FOURTH AMENDMENT TO THE
MASTER DEED FOR PINE ARBOR CONDOMINIUM
as required by the Michigan Condominium Act,
MCLA 559.101 et seq., MSA 26.50(101) et seq., as amended.

Wayne County Condominium Subdivision Plan No. 834, Replat No. 4.

REPLAT NO. 4
WAYNE COUNTY CONDOMINIUM SUBDIVISION PLAN NO. 834
EXHIBIT B TO AMENDED MASTER DEED OF
PINE ARBOR CONDOMINIUM
PART OF THE NORTHWEST 1/4 OF SECTION 28,
T.4S., R.10E., CITY OF WOODHAVEN,
WAYNE COUNTY, MICHIGAN

PINE ARBOR CONDOMINIUM
REPLAT NO. 4

SITE PLAN

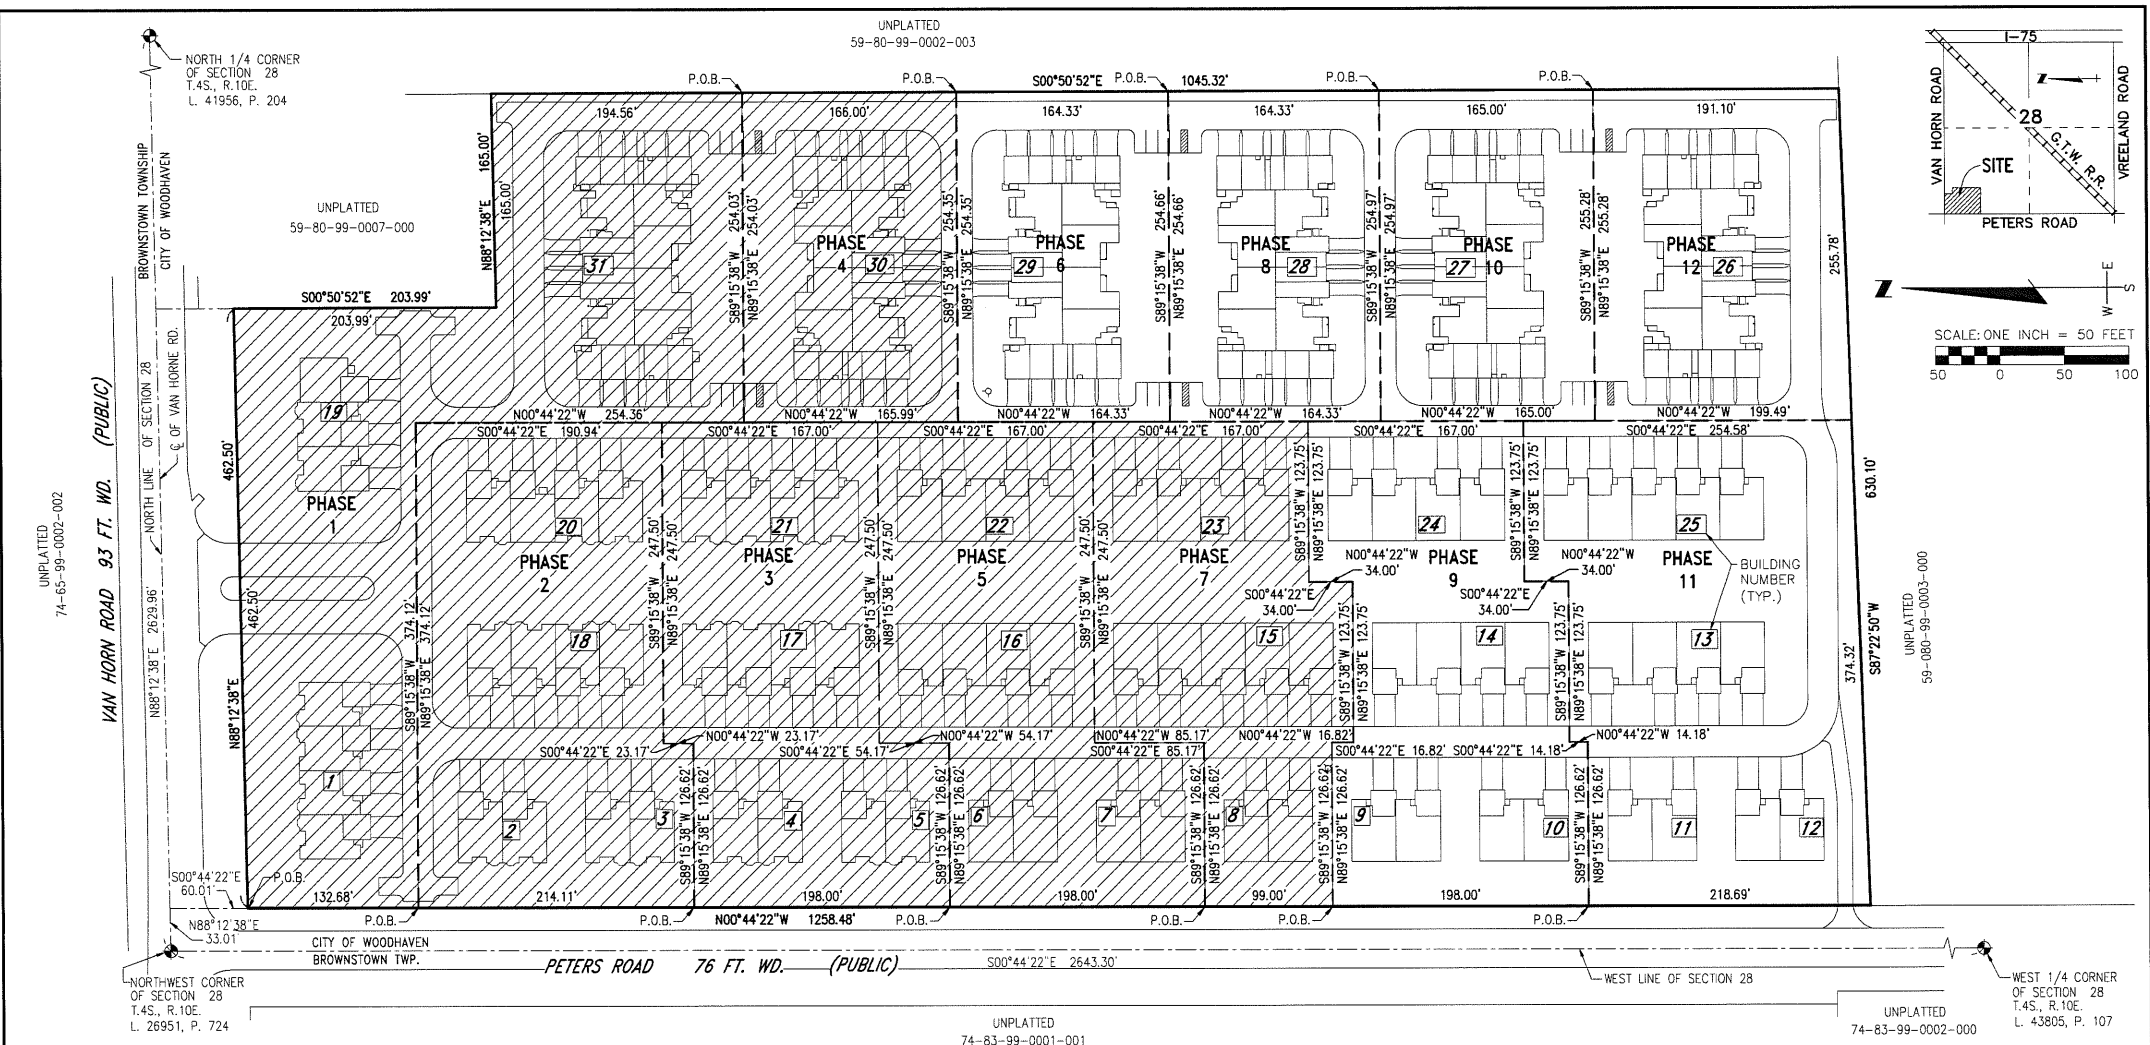
Second Change: The following pages of Exhibit B are revised by inserting new pages or substituting the attached pages for the pages originally recorded:

Sheet 1	Cover Sheet
Sheet 1A	Phase Legal Descriptions
Sheet 3	Site Plan
Sheet 3A	Phase Boundary Detail Plan
Sheet 4	Utility Plan
Sheet 5	Easement Plan
Sheet 9	Cross Section D-D, Buildings No. 26-31

- THE UNITS AS SHOWN IN PHASES 1, 2, 3, 4, 5 AND 7 MUST BE BUILT. THOSE PHASES INCLUDE THE FOLLOWING UNITS:
PHASE 1 CONSISTS OF UNITS 1-4, 77-93
PHASE 2 CONSISTS OF UNITS 5-8, 27-30, 52-55
PHASE 3 CONSISTS OF UNITS 9-12, 31-34, 56-59
PHASE 4 CONSISTS OF UNITS 94-107
PHASE 5 CONSISTS OF UNITS 13-16, 35-38, 60-63
PHASE 7 CONSISTS OF UNITS 17-18, 39-43, 64-67
THE UNITS AS SHOWN IN PHASES 6 AND 8 THROUGH 12 WILL NOT BE BUILT UNLESS AND UNTIL AN AMENDMENT TO THIS MASTER DEED IS RECORDED TO AUTHORIZE CONSTRUCTION IN THAT PHASE.
- DRIVEWAYS, PORCHES, PATIOS AND DECKS ARE LIMITED COMMON ELEMENT.
- SEE SHEET 3A FOR PHASE BOUNDARY DETAIL.
